MEMORANDUM

SUBJECT: Impromptu visual cap inspection at the San Jacinto River

Waste Pits superfund site

Figure 1- Areas to be covered with additional rock and flatten slopes from November 2013 Armor Cap Enhancement plan $\,$

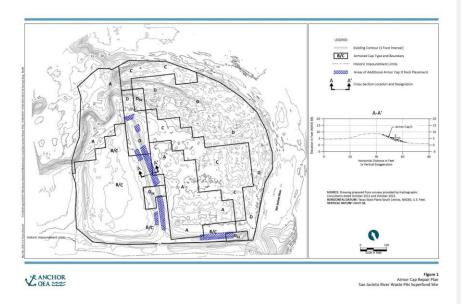
Commented [MJ3]: What was the purpose of highlighting these 7 areas? Are they not part of the overall cap?
